ADDENDUM NO. 03 5 April 2010

Project: **A NEW TRANSPORTATION FACILITY**
Dickinson Independent School District

Project No.: **0806**

4. This Addendum consists of two (2) 8-1/2x11 written pages, and two (2) 30x42 attached full size sheets; **S1.1** and **S1.2**; as prepared by Concept Engineers. Total pages: 4 pages.

S1.2
 ROOF PLAN & DETAILS
 CHILD NUTRITION BUILDING

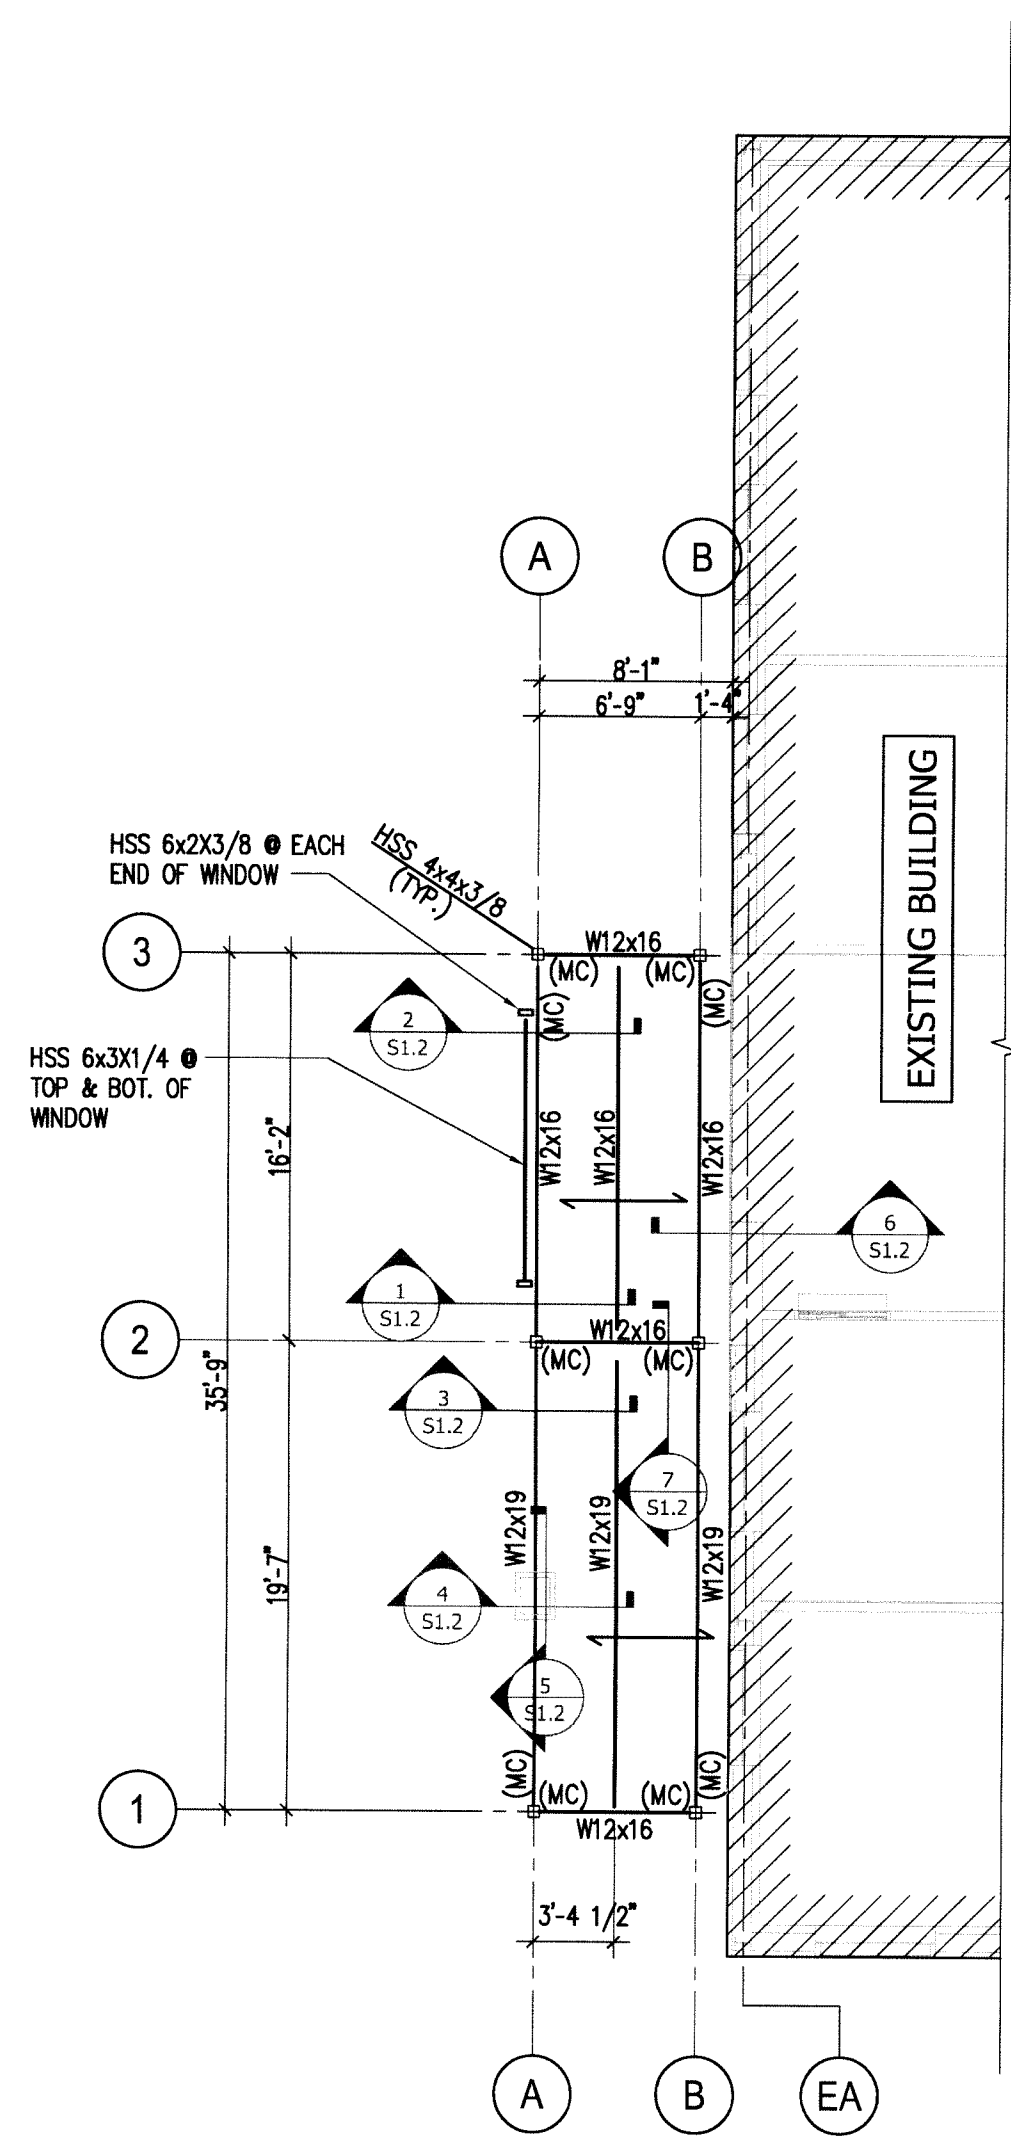
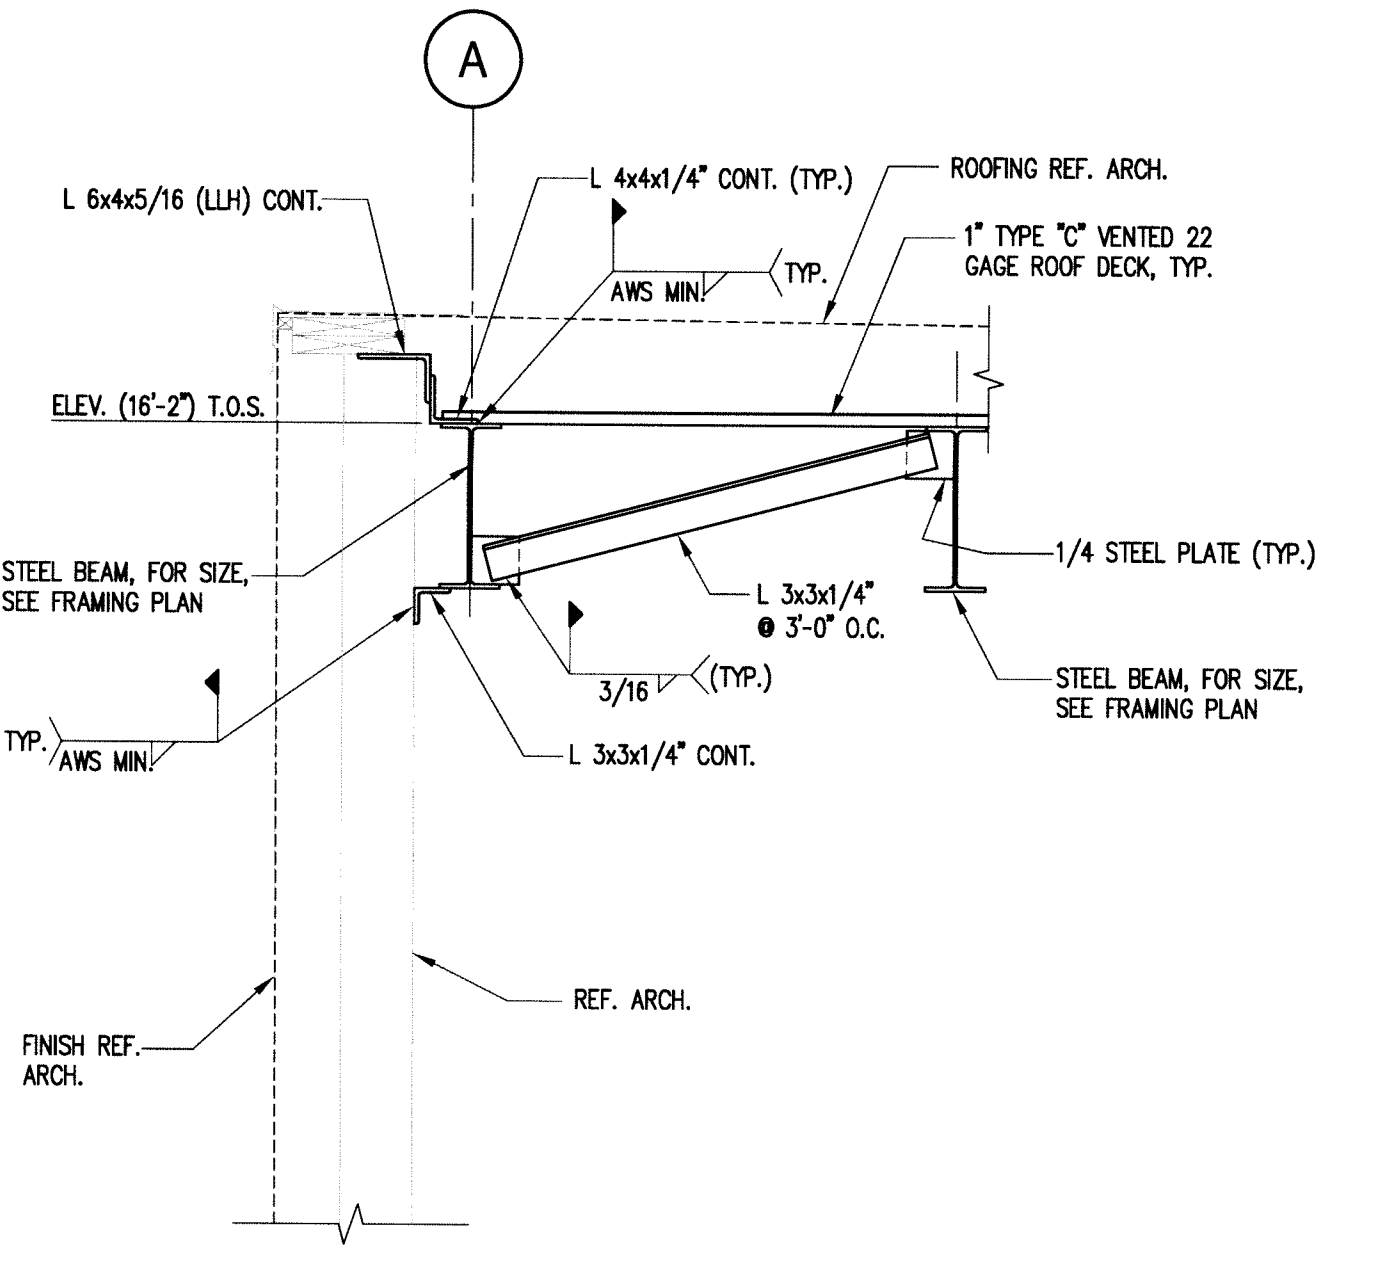
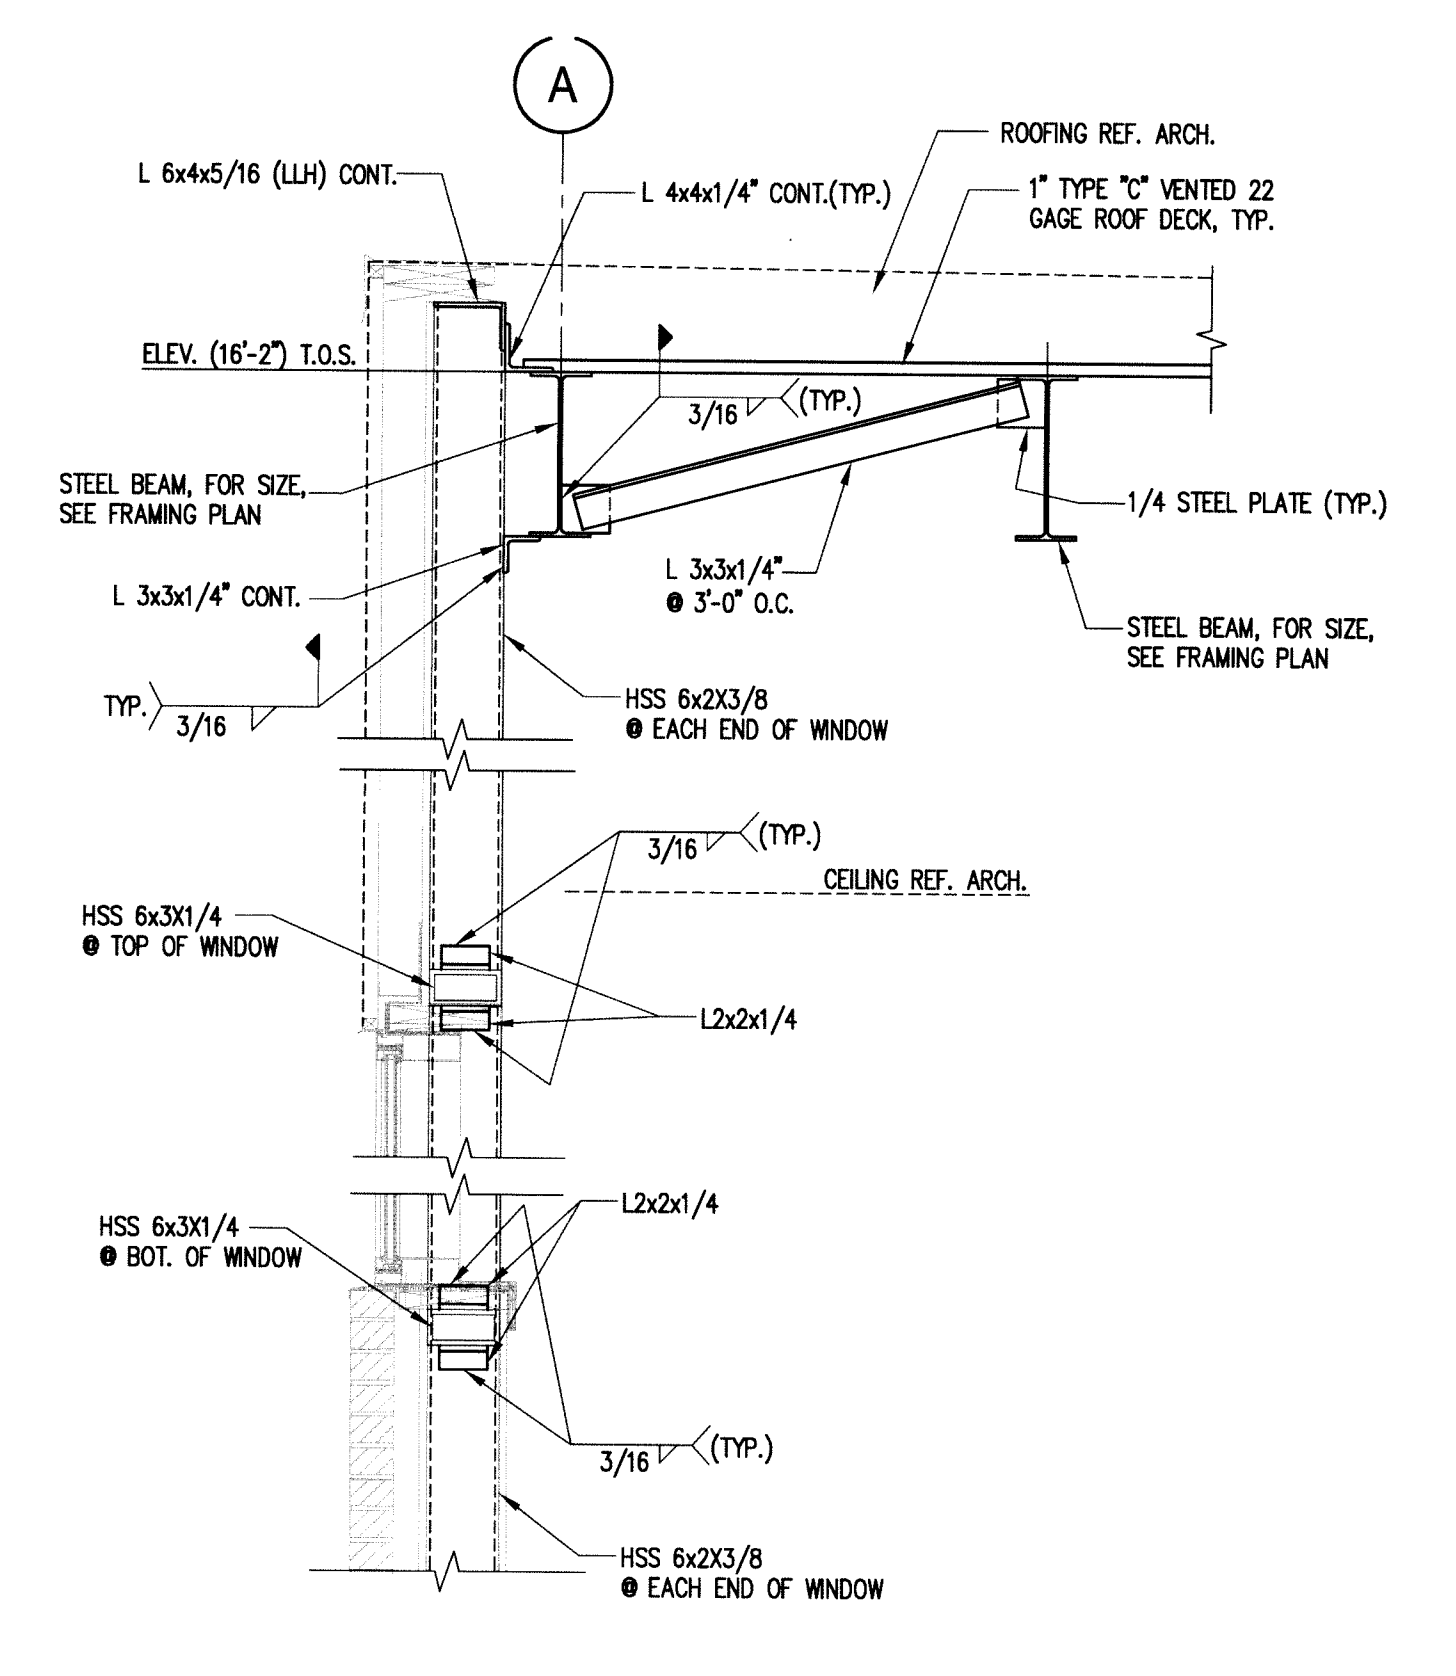
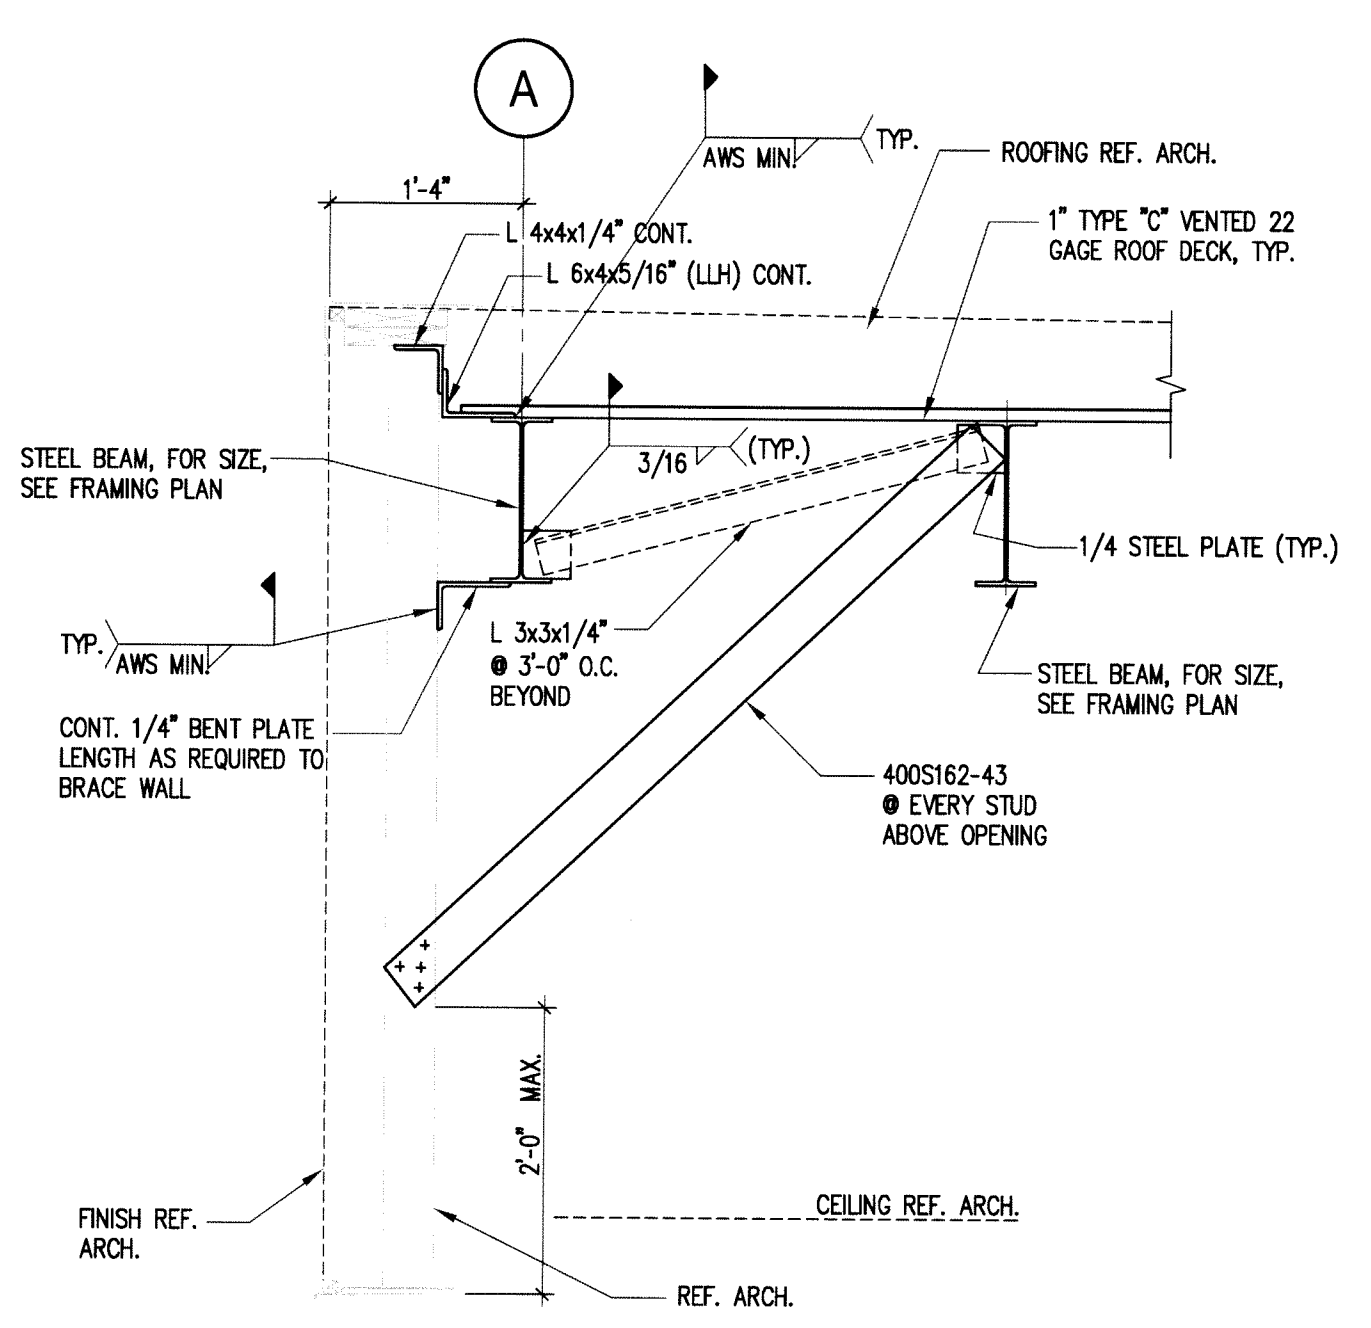
8. Sheet S1.1 Foundation Plan & Details Child Nutrition Building: Add foundation plan and details of entrance area of Child Nutrition Building. Also add the foundation plan and details to support fuel tank at fuel dispensing area.
9. Sheet S1.2 Roof Plan and Details Child Nutrition Building: Add roof framing plan and details of entrance area of Child Nutrition Building.
